Wright-Ryan Construction Inc
REQUEST FOR INFORMATION

PROJECT: Oak Street Efficiencies
JOB: 1104

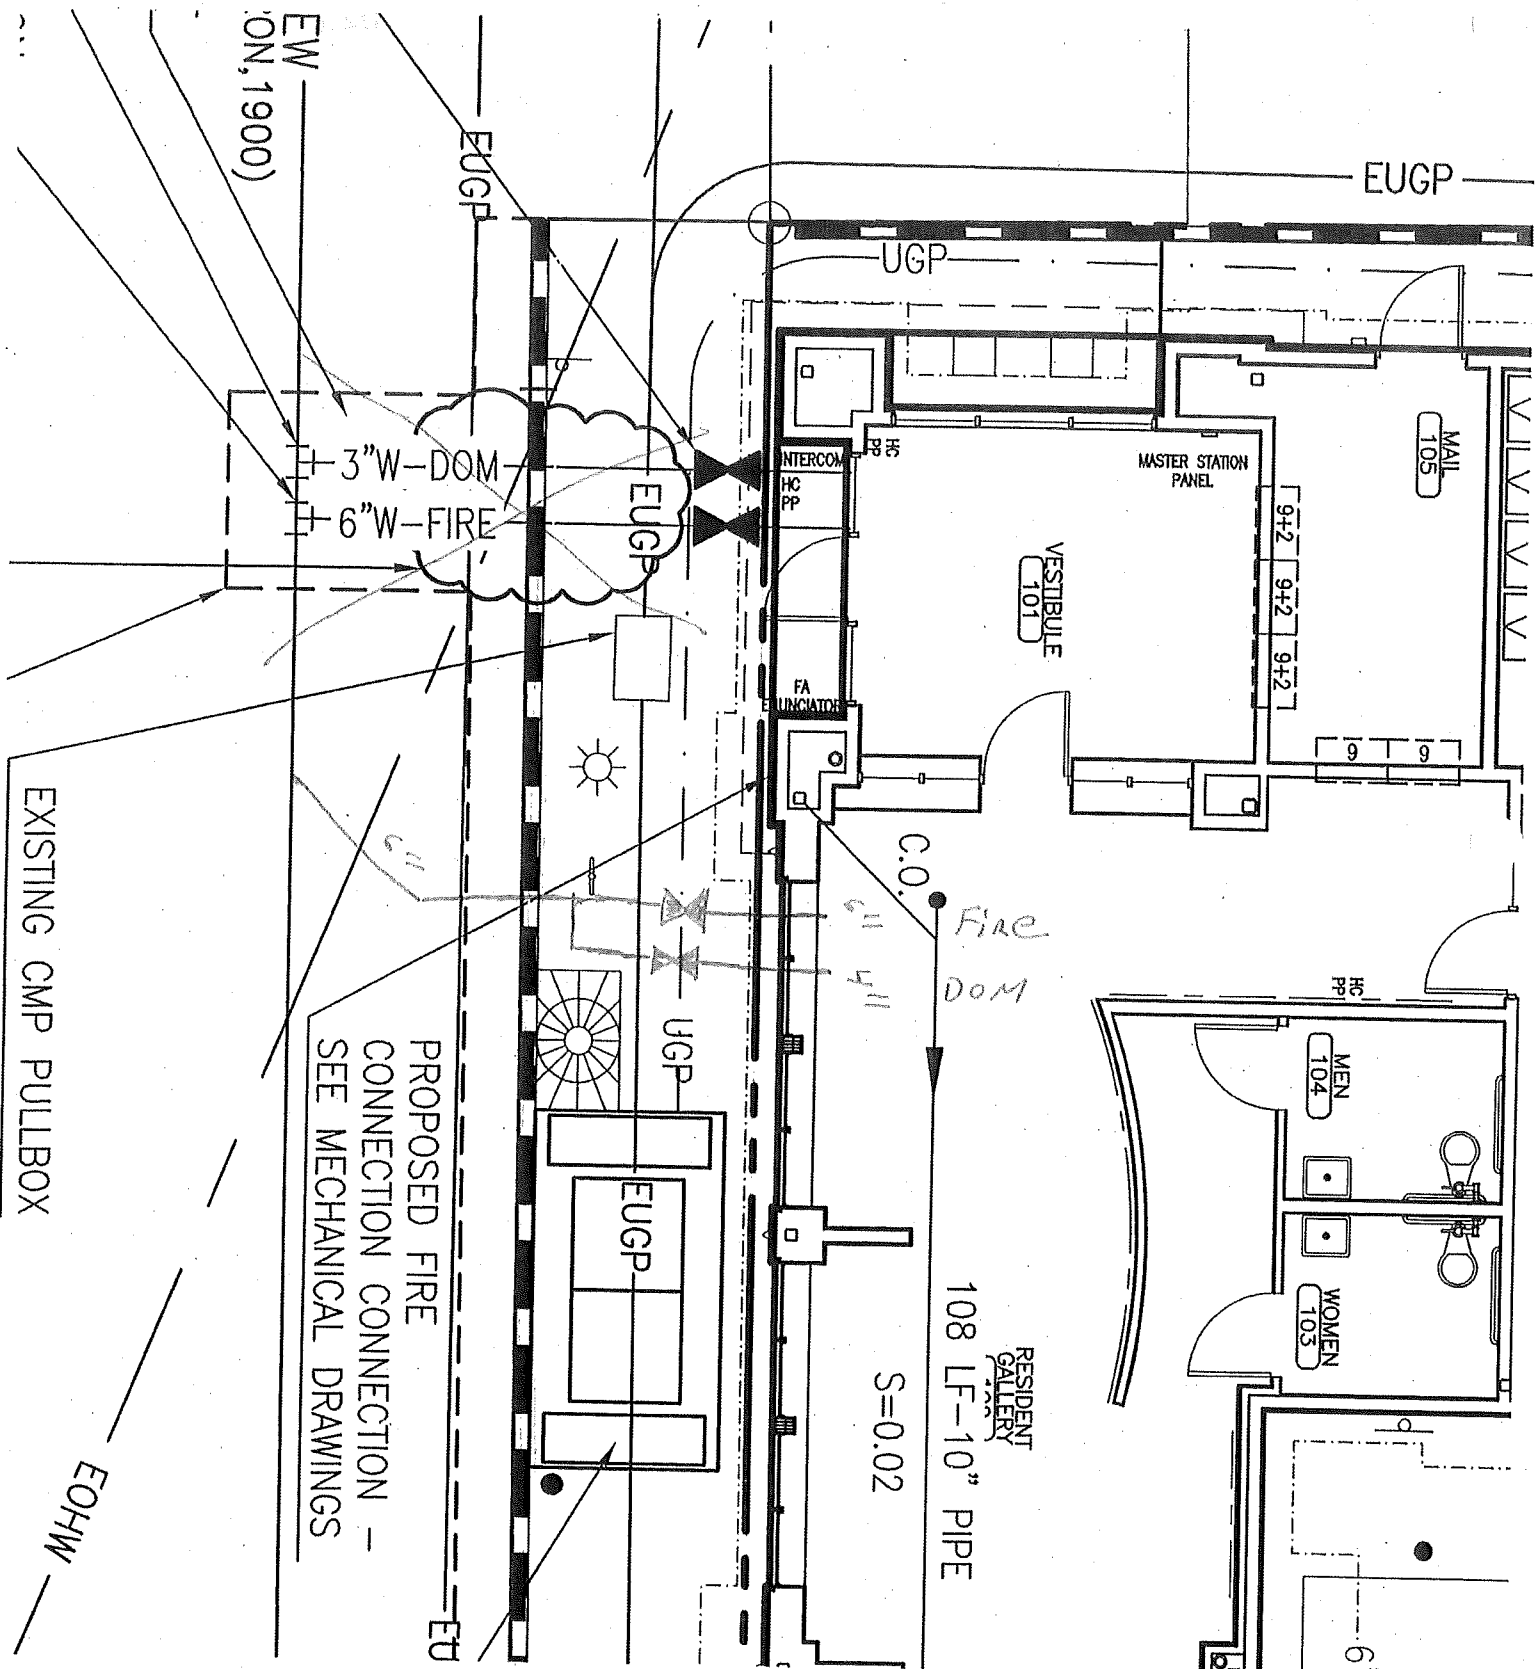
Due to all of the unforeseen conditions beneath Oak Street, the water service connection to the main is impossible as drawn. We are requesting to make one connection to the water main. This one line would run under a CMP existing ductbank in Oak Street. Once we clear the duct bank the line would then branch out to two lines (one for domestic water and the other for sprinkler service).

Please see the attached sketch.

The Portland Water District has issued approval for this change provided the branch is made within the right-of-way, two valves are provided at the property line as shown, and the sprinkler system designer has signed off on the pipe sizing.

The architect, mechanical engineer and landscape architect have reviewed the sketch and approved of the change.

HOLLOW METAL DOOR ELEVATIONS

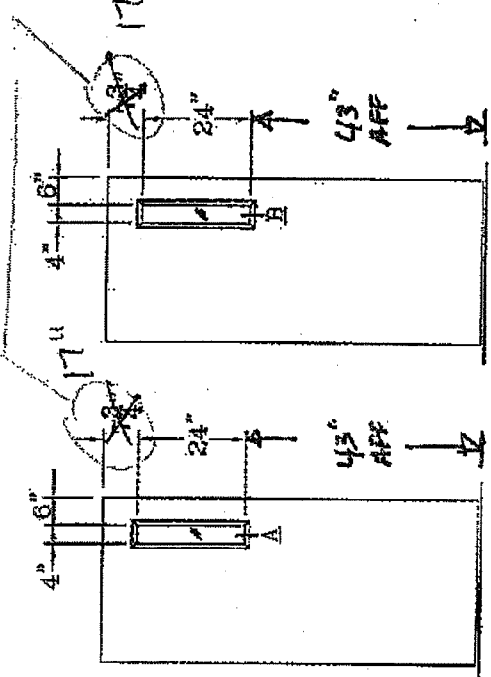
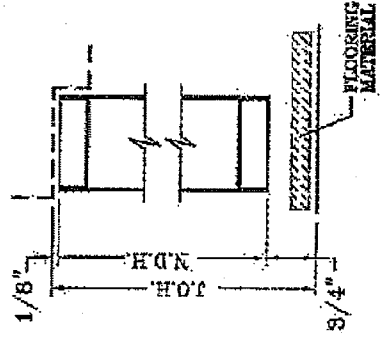
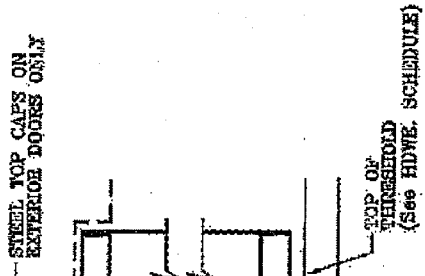
Note: If we drop the glass kits in all doors to 43" A.F.F. per ANSI 117.1 we will have the following conditions:

Door Elevations NVL.1, NVL.2 and NVL will have a dimension from the top of the door to the exposed glass of 17" +/-.

Door Elevation HG1 will have a dimension from the top of the door to the exposed glass of 11" +/-.

Are these acceptable with the Architect(s) or do they want to change the glass sizes?

Note: Lowered narrow vision lites are required at all NVL doors. Glass size in all NVL cases cannot be increased. At HG1 doors, glass size can be increased and as such we would like to increase the glass height to 33" in order to maintain the head at a more conventional height if it is a no-cost change. The lower edge of glass does need to be at 43".

SKM-7

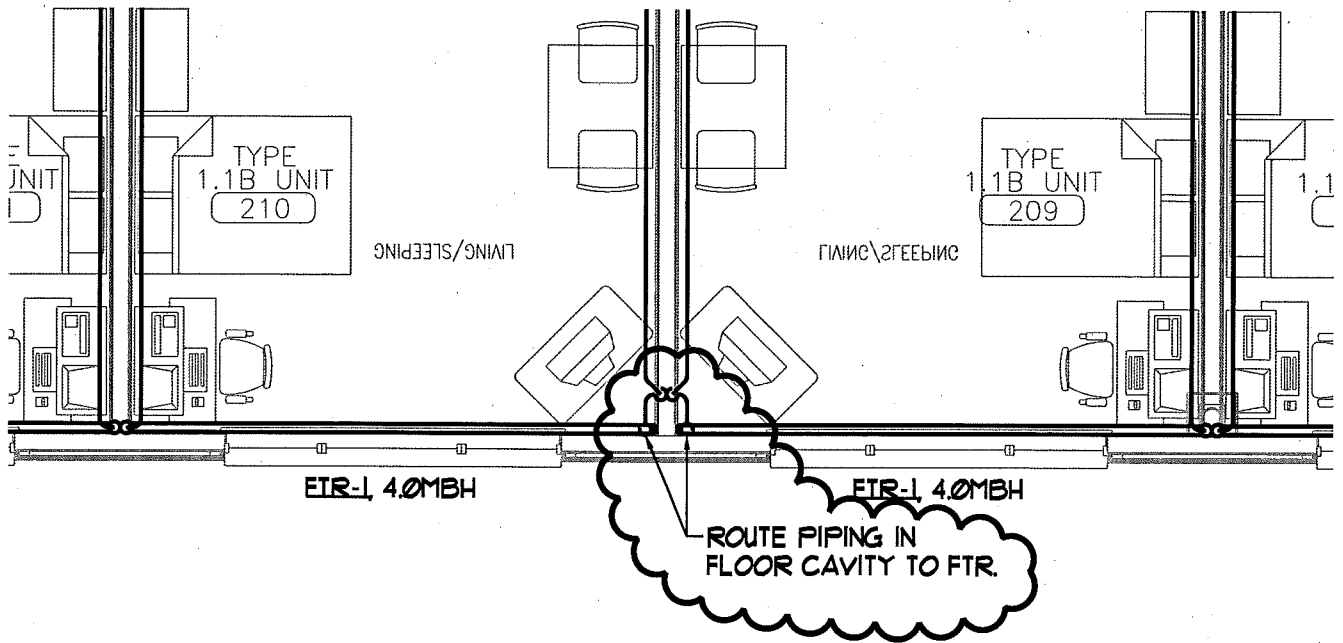
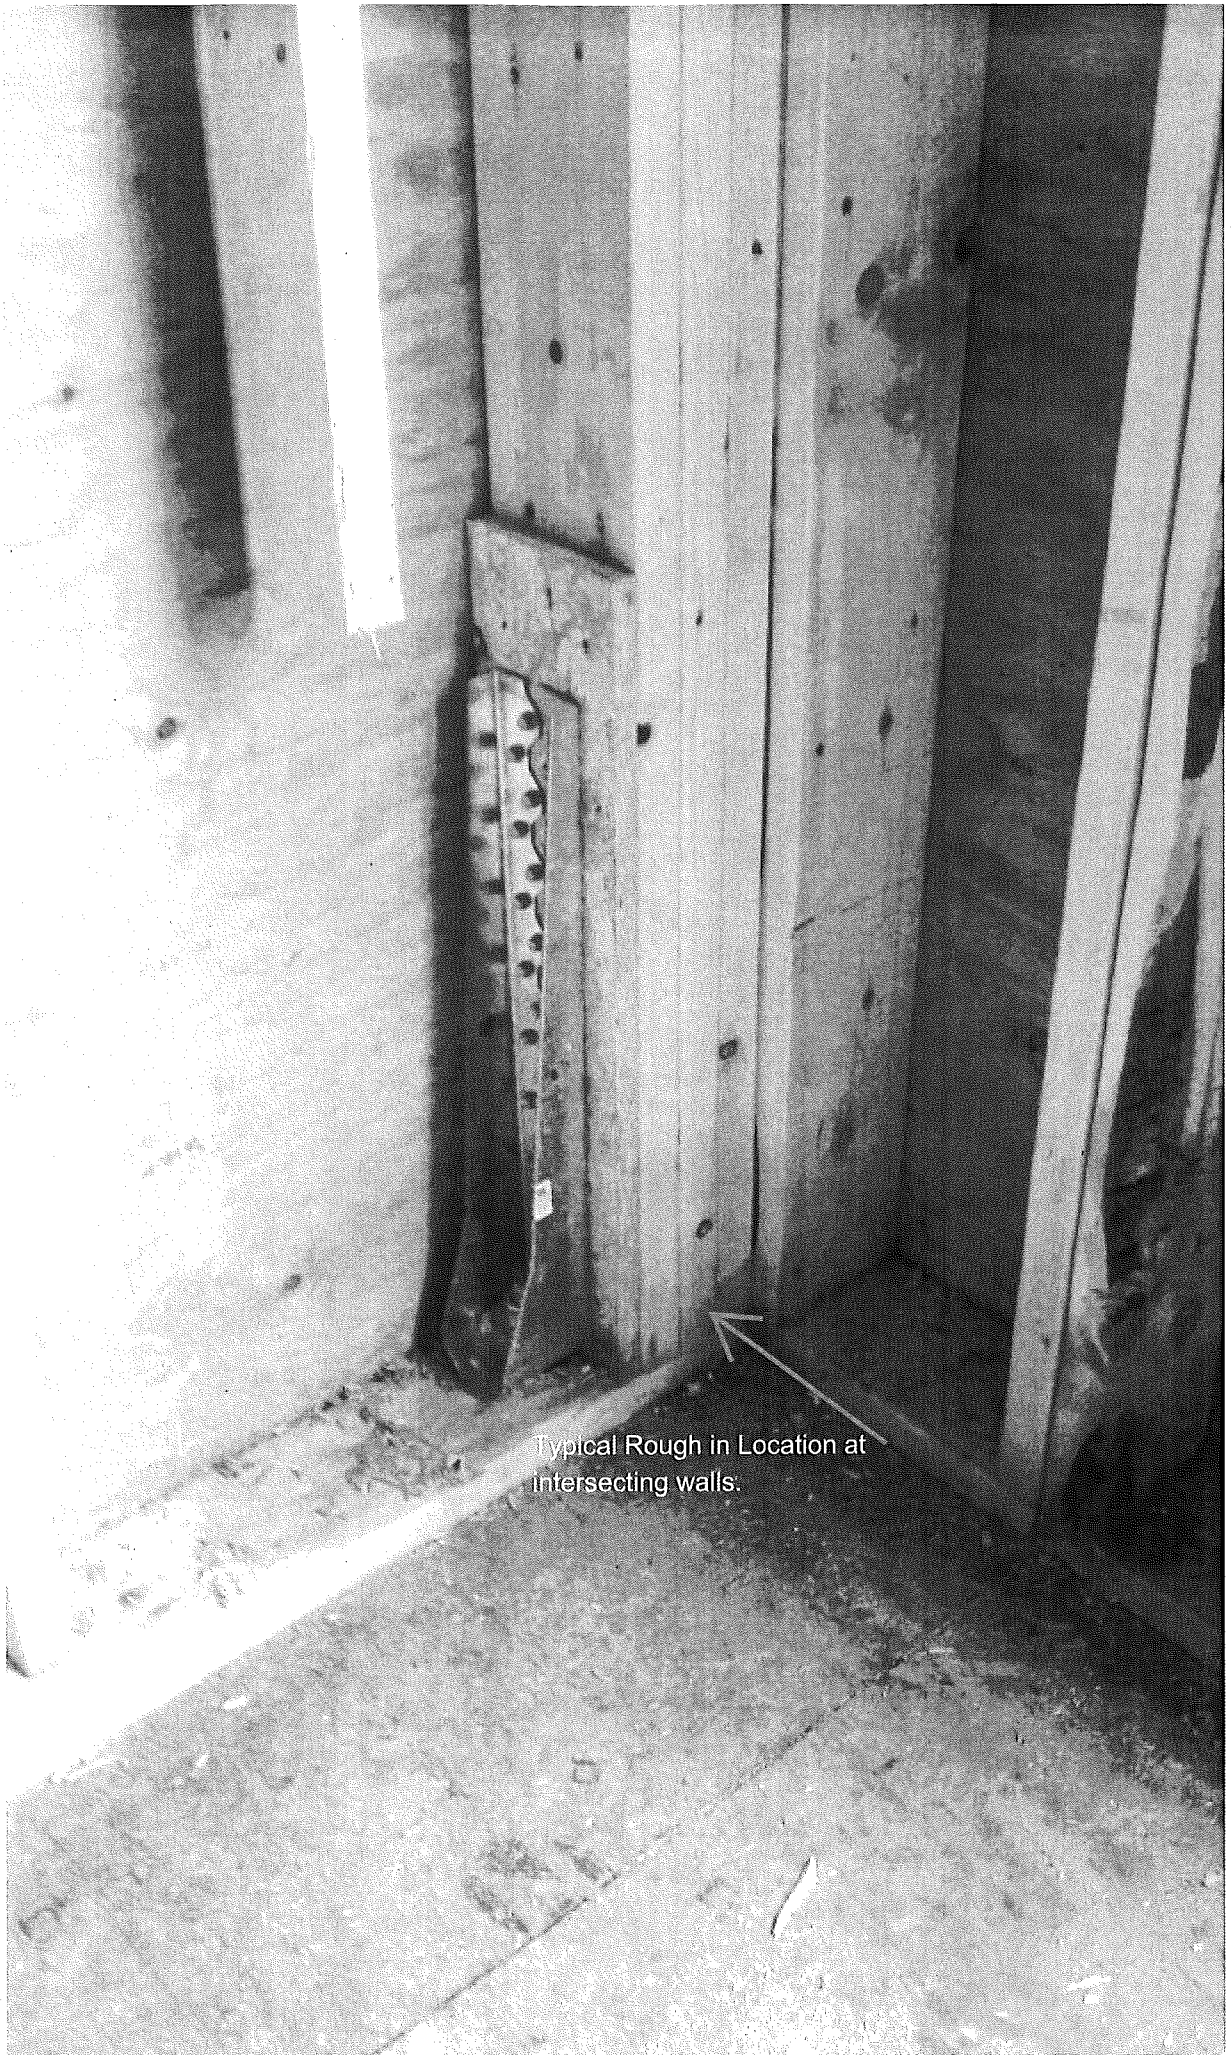
The mechanical drawings show the 3/4" heating lines feeding the hot water baseboard at the exterior & shear wall locations where the Simpson Hold-down brackets are located, thus making the heat line installation impossible at these locations. Refer to the attached photo for reference.

Please revise heat pipe routing such that riser and drop locations at shear connectors are inboard of the connectors. Piping shall continue through plates and into floor/ceiling cavities to avoid connectors before off-setting and connecting to baseboard heat through floor connections. See attached SKM-7.

Sheet Number:
E1.3

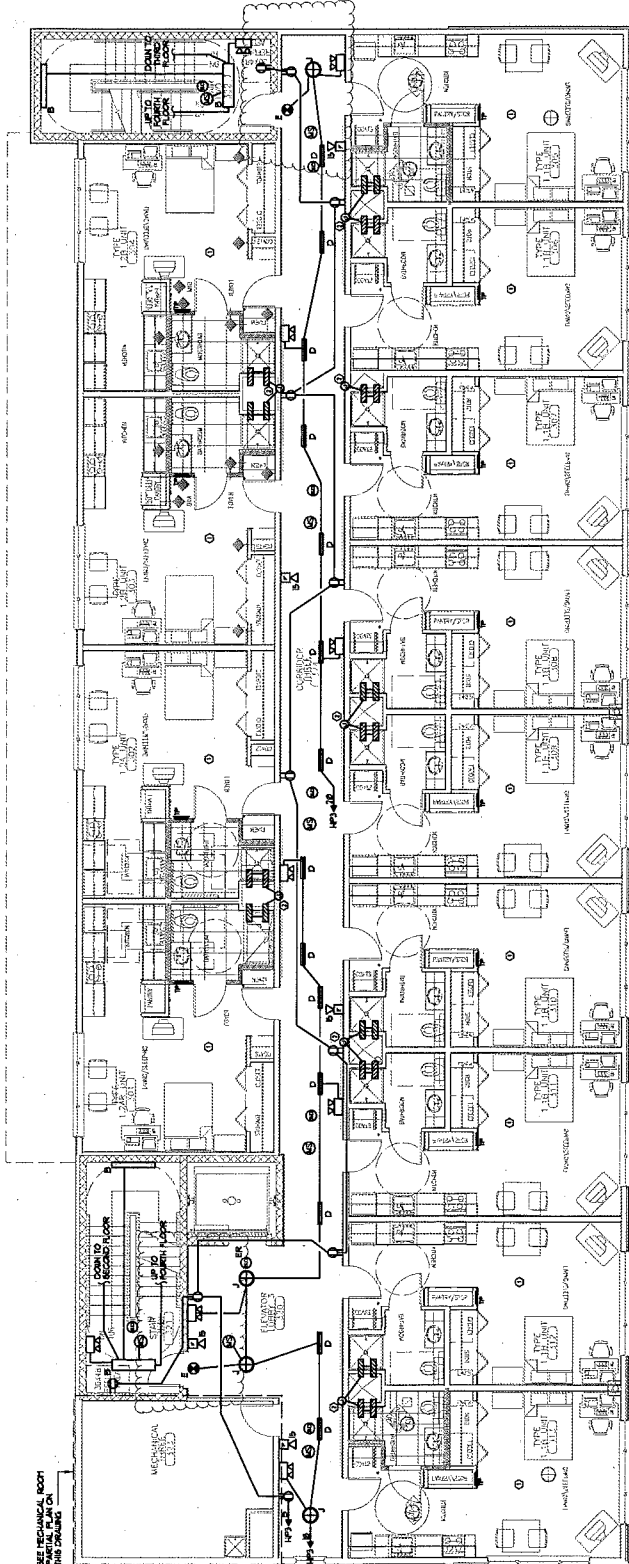
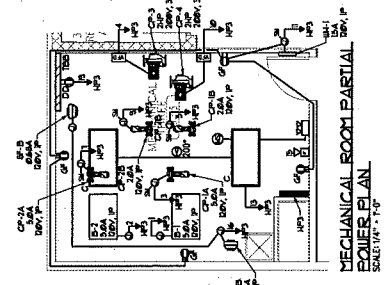
Reference the attached electrical drawing E1.3. The areas clouded on the third floor near the stair towers require fire alarm pull stations to abide by code, but no pull stations are detailed.

Please provide change proposal pricing to add pull stations at required locations on the third floor.
